PROJECT NAME: WEATHERSFIELD  
PROJECT NUMBER: CMG PARK(17)S

TYPICAL SECTIONS

FILE NAME: z99k014sht\_lay.dgn  
 PROJECT LEADER: Wayne L. Davis  
 DESIGNED BY: AGB  
 PLOT DATE: 8/20/2008  
 DRAWN BY: AGB  
 CHECKED BY: SJG  
**PLAN SHEET**  
 SHEET 9 OF 36

FILE NAME: z99k014sht\_lay.dgn  
PROJECT LEADER: Wayne L. Davis  
DESIGNED BY: AGB  
MISCELLANEOUS DETAILS SHEET

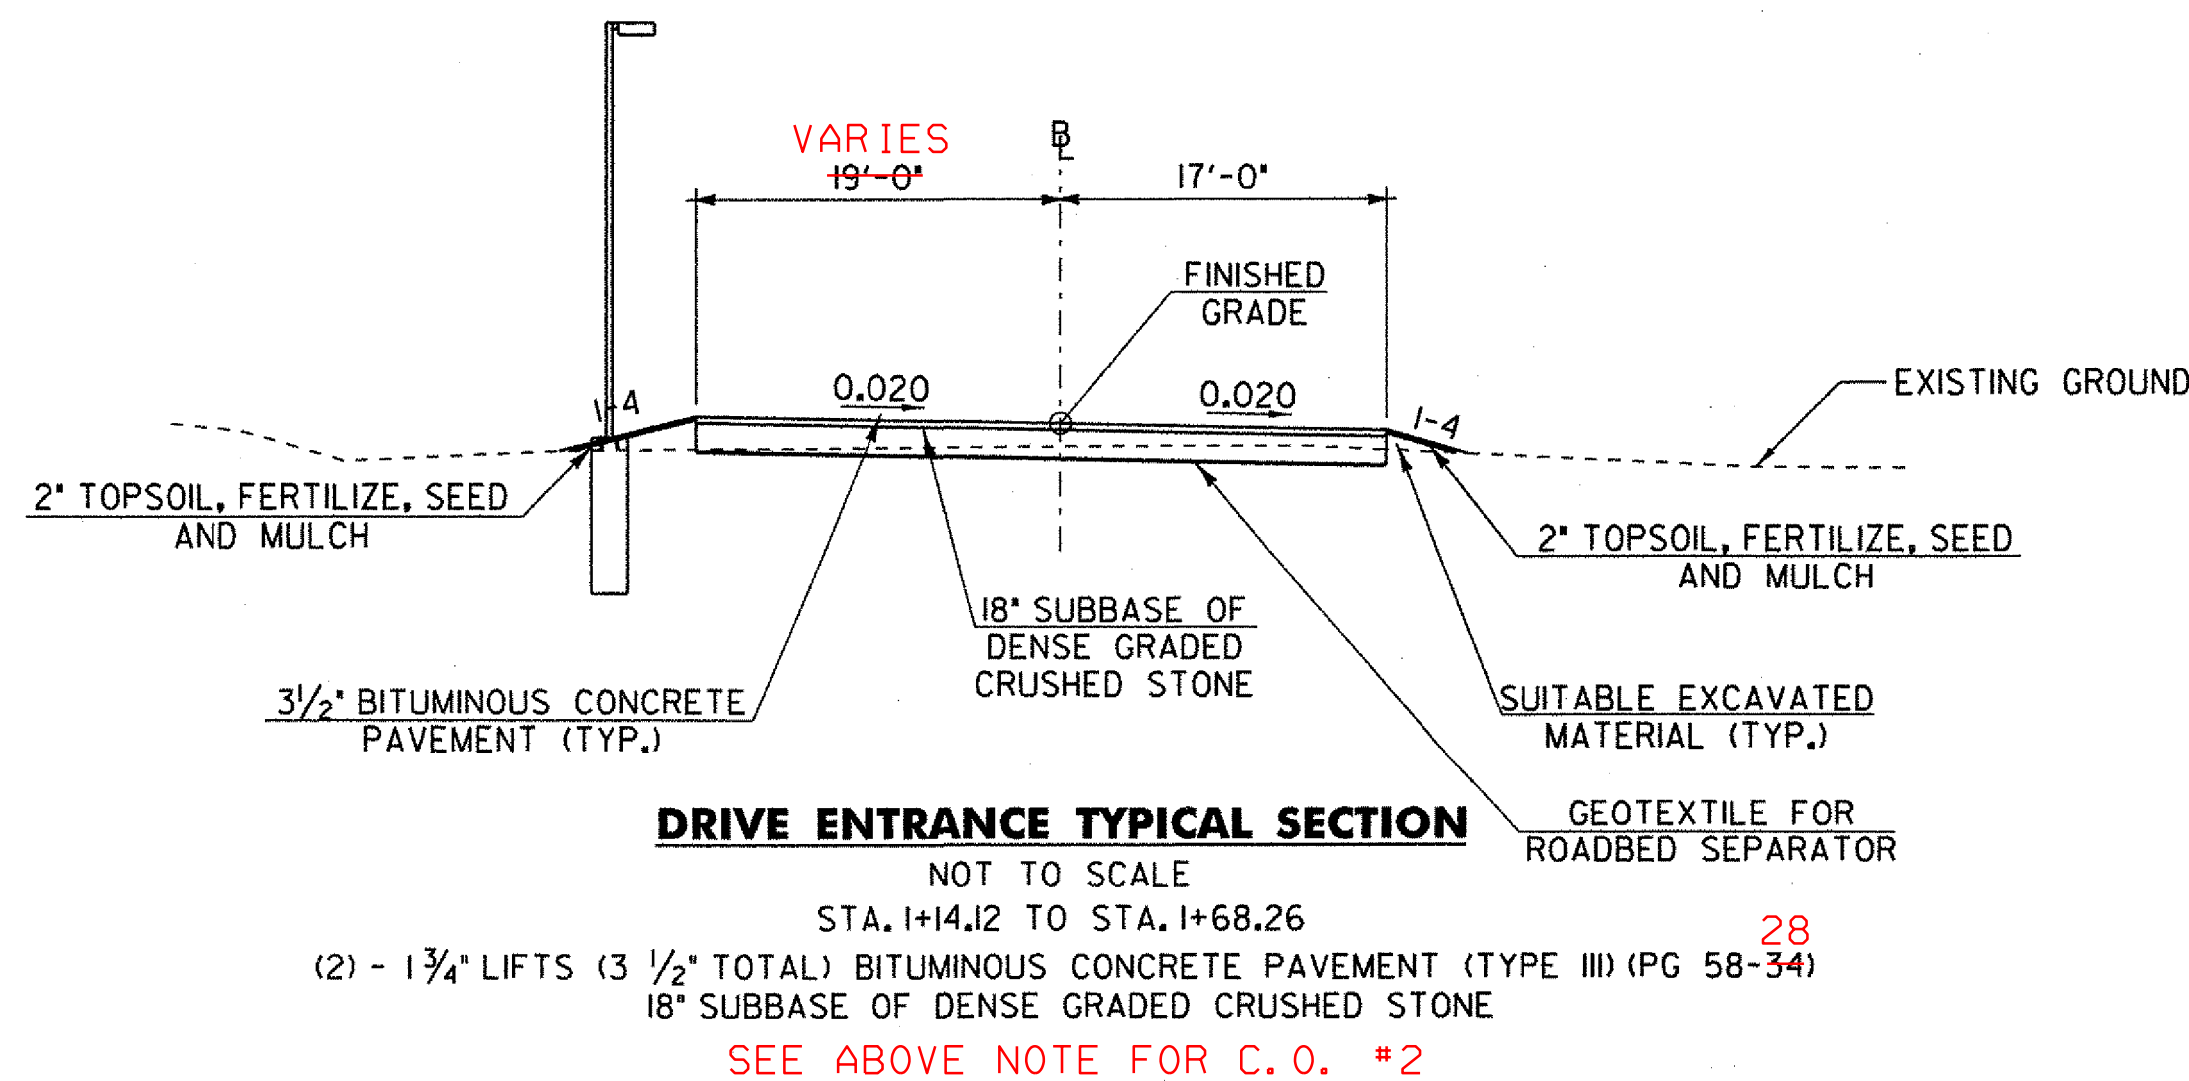
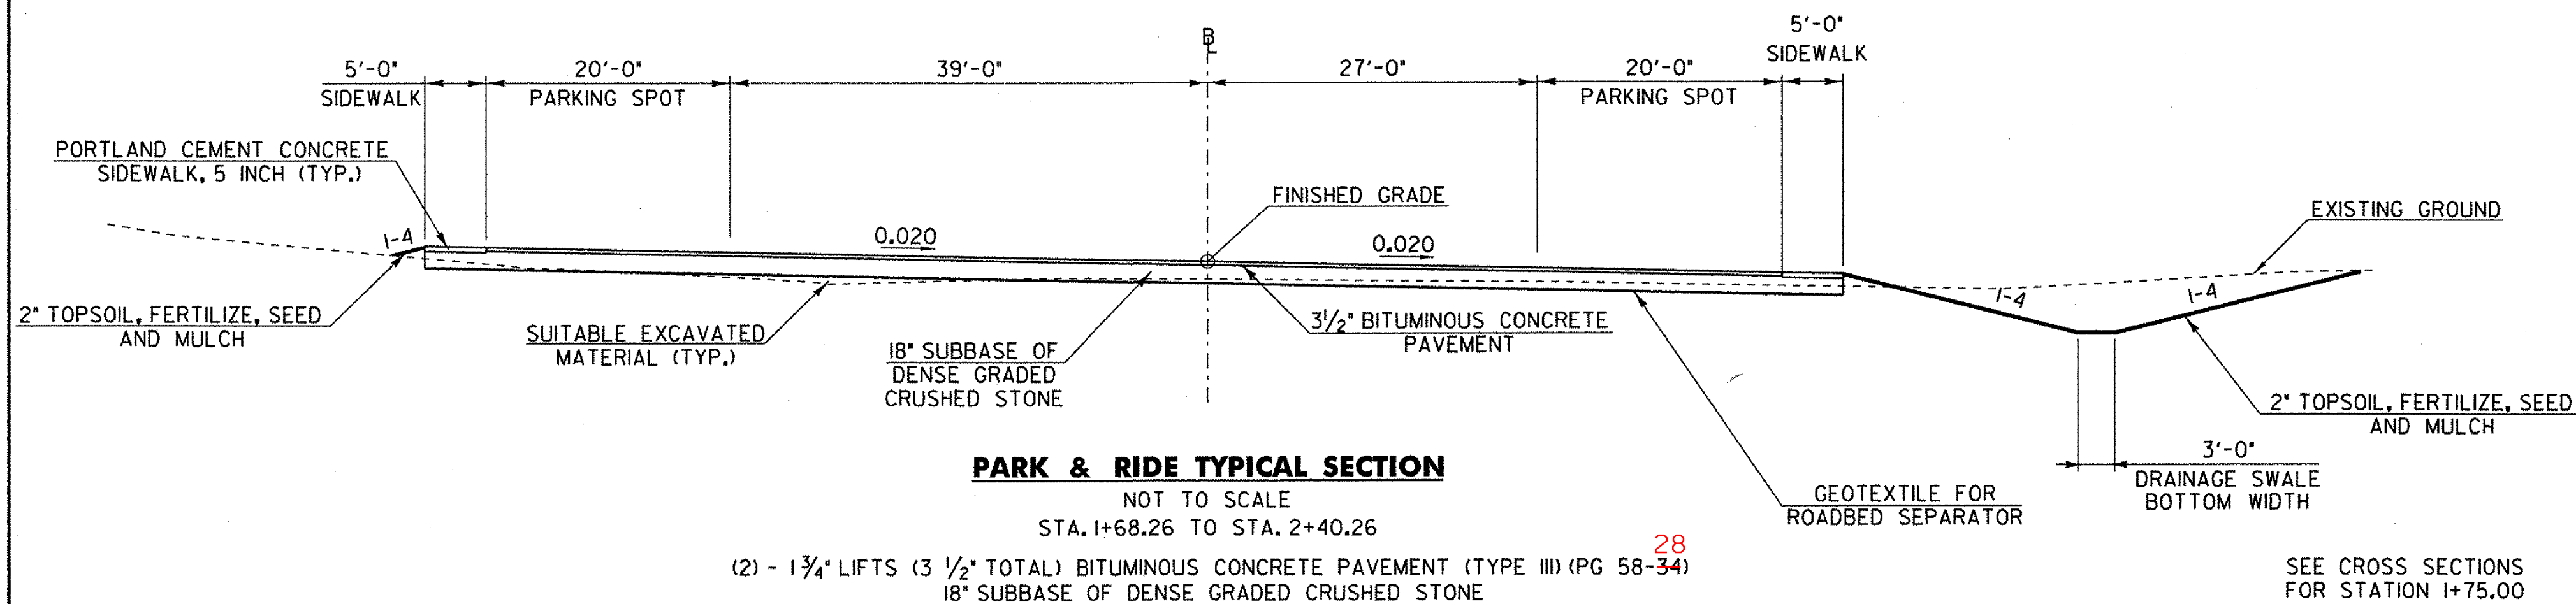
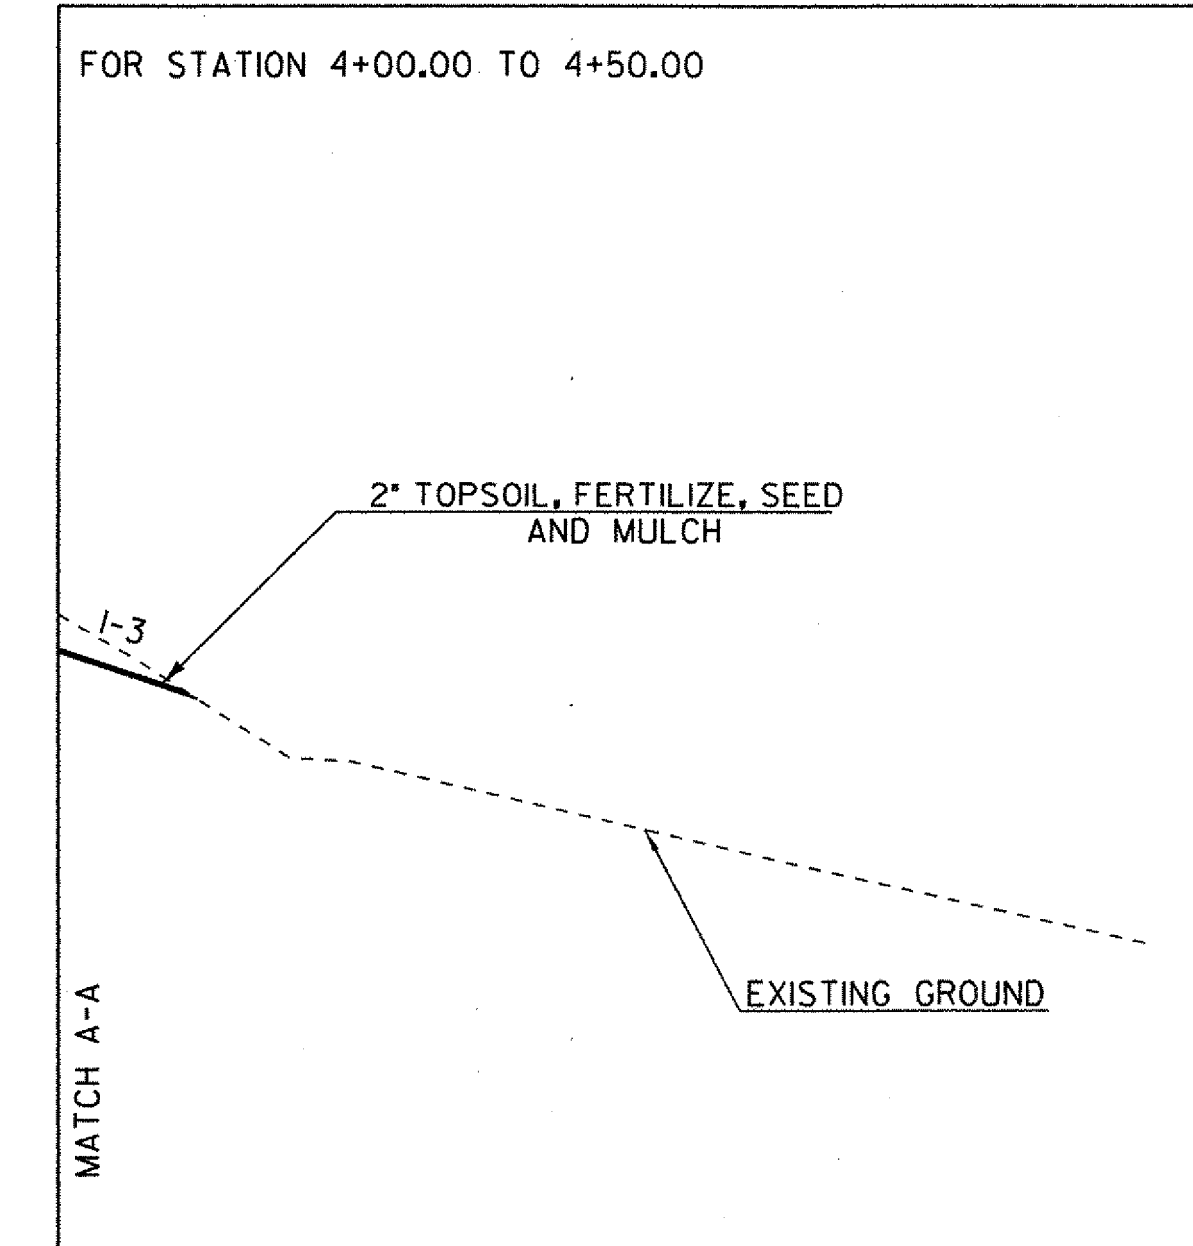
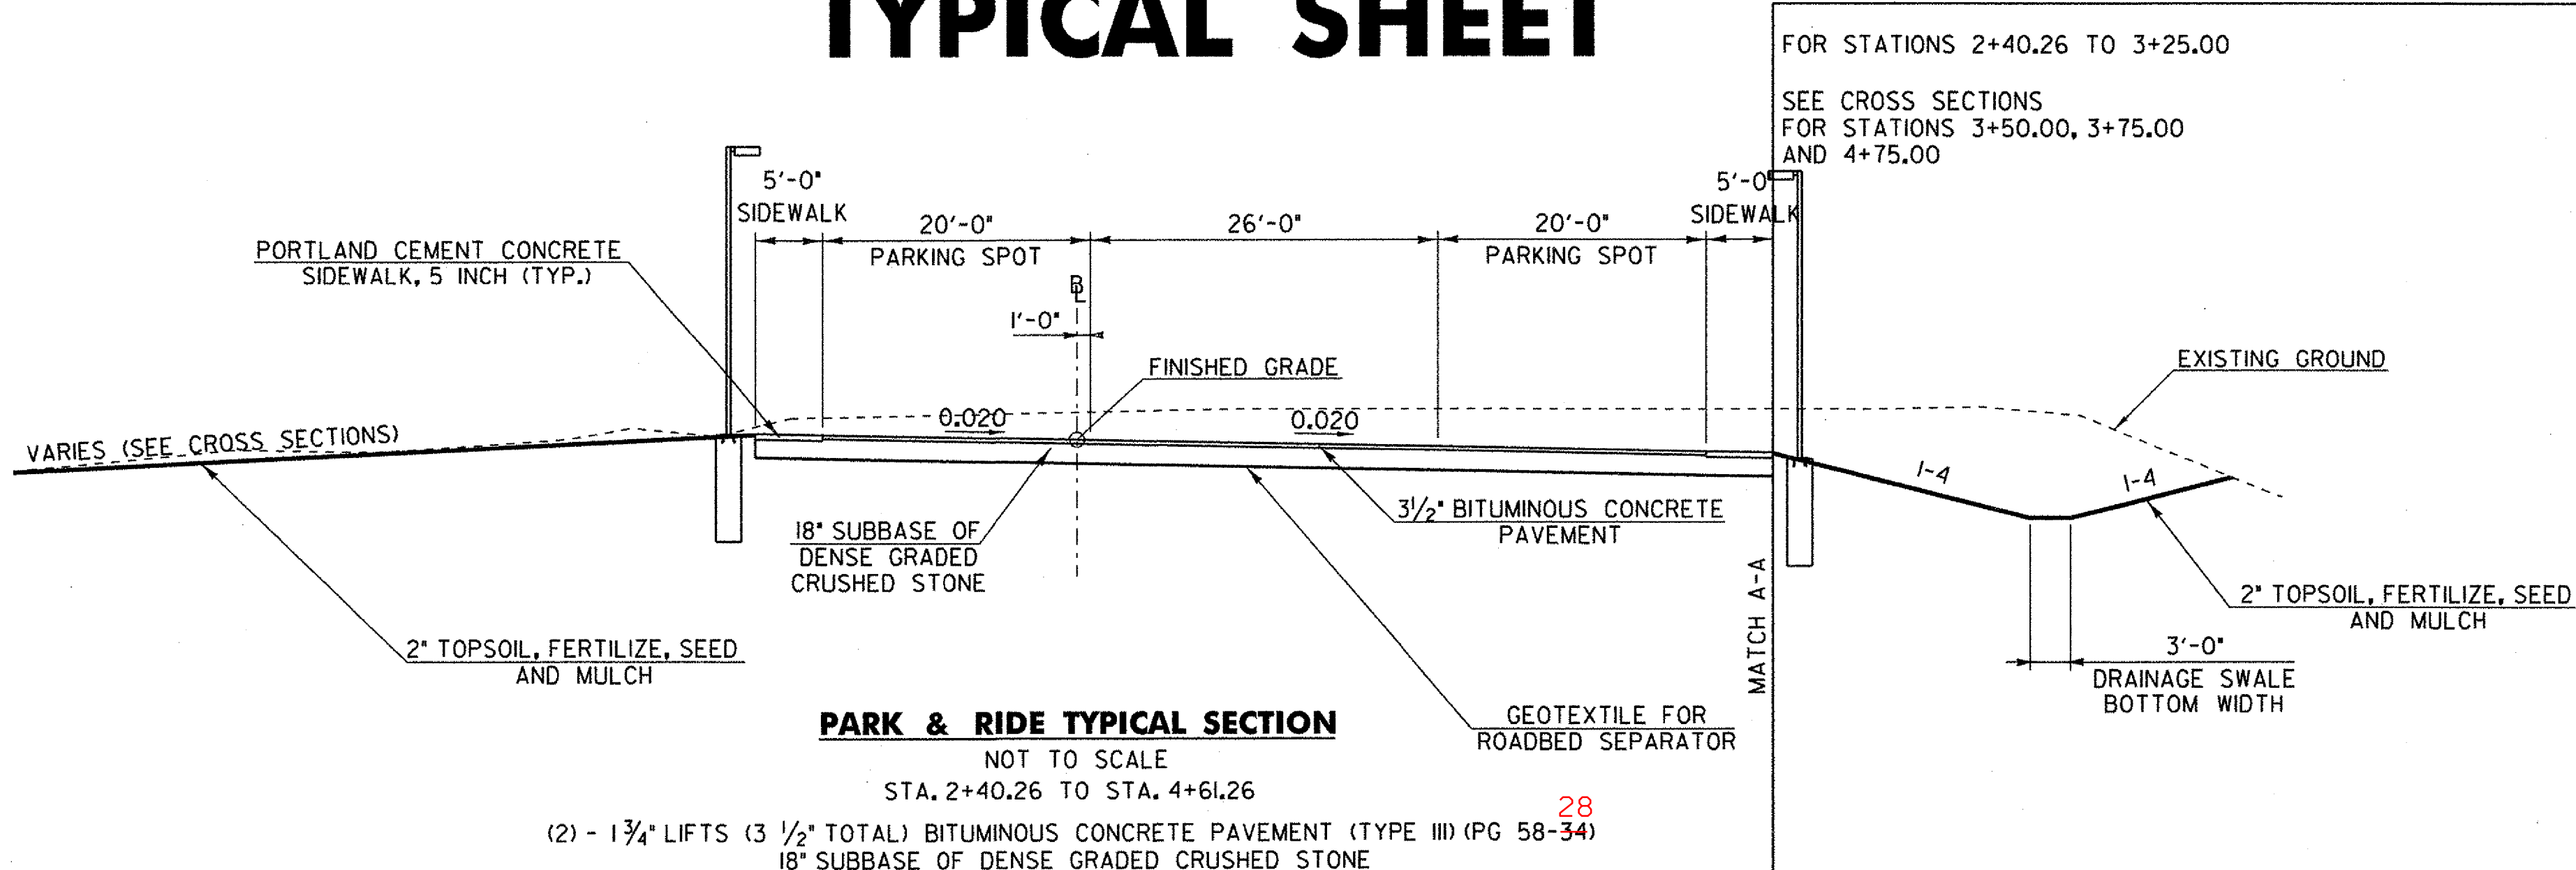
**CHANGE ORDER #4 WORK**  
 DUE TO THE ORIGINAL DESIGN, WHICH DID NOT ACCOUNT FOR DRAINAGE FROM THE HIGH POINT (PVI) AT STA. 1+65 WHERE DRAINAGE WATER WOULD FLOW TOWARDS AND ONTO RT 131. A SWALE WAS EXCAVATED AT STA 1+15 LT TO 1+35 RT. THE SWALE WAS CONSTRUCTED SO THAT THE DRAINAGE WATER FLOWS TO THE LT. AT STA 1+15 +/- LT.  
 SEE C.O. #4, DATED 06/25/09

PER C.O. #3, DATED 06/16/09, THREE CABLES WERE INSTALLED, ALL DEAD LIMBS WERE PRUNED AND REMOVED, AND ALSO THE CROWN WAS PRUNED TO PRESERVE THE TREE

\*AS PER NOTE FOR 04/29/09  
 IN BOOK #1, PG. 81 18" CPEP  
 EXITS THE DMH AT STA. 1+75 RT.  
 THE SIZE OF THE PIPE IS BELIEVED  
 TO CHANGE AT STA 2+75 +/- RT.  
 SINCE THE PIPE AT THE OUTLET  
 IS 24" CSP

FILE NAME: z99k014sht\_lay.dgn  
 PROJECT LEADER: Wayne L. Davis  
 DESIGNED BY: AGB  
 PAVEMENT MARKING & SIGNS SHEET

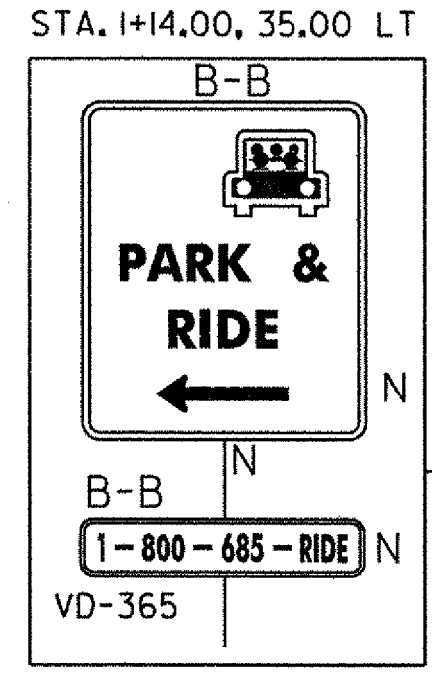
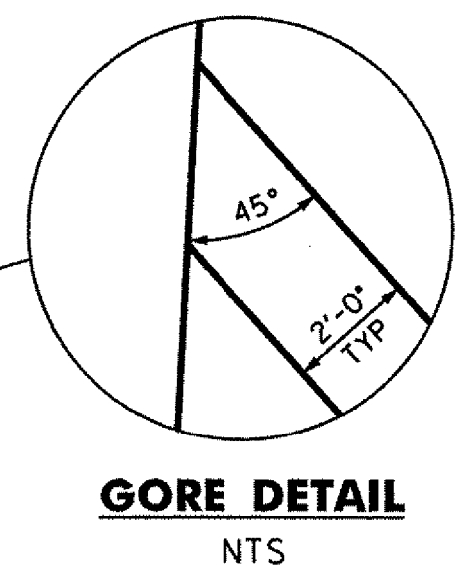
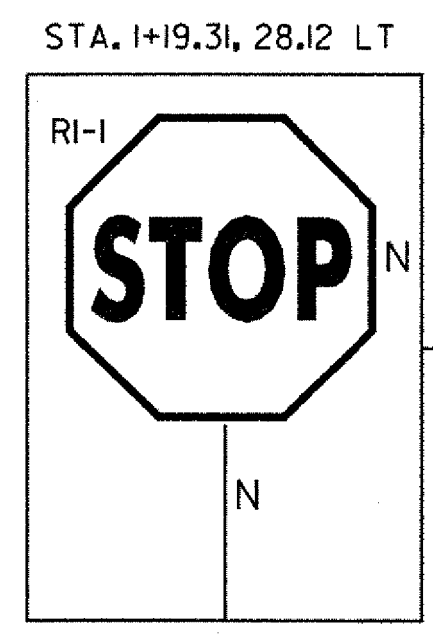
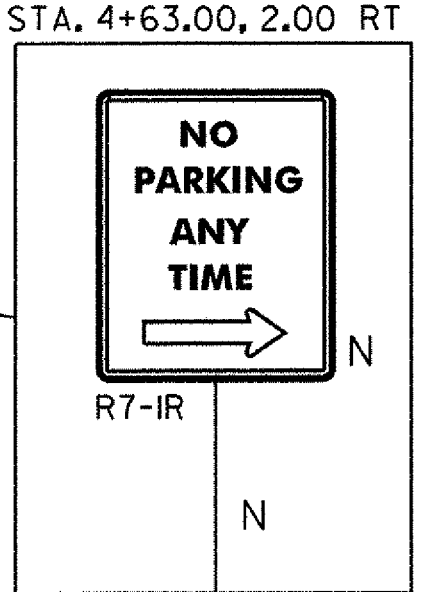
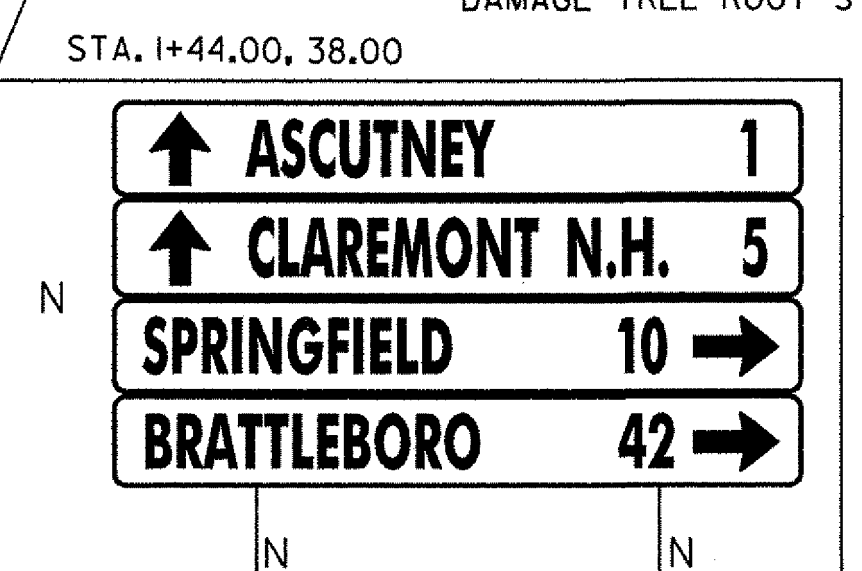
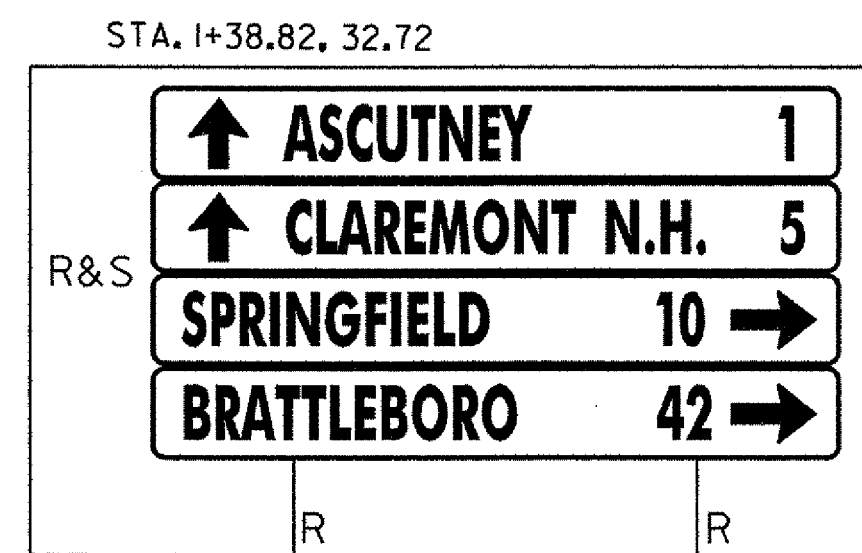
**DURABLE 4 INCH WHITE LINE**  
 PARKING SPOT LINES  
 HANDICAP HATCHING  
 END PARK AND RIDE LOT HATCHING  
 THESE END LINES WERE NOT INSTALLED THE HATCHING WAS INSTALLED
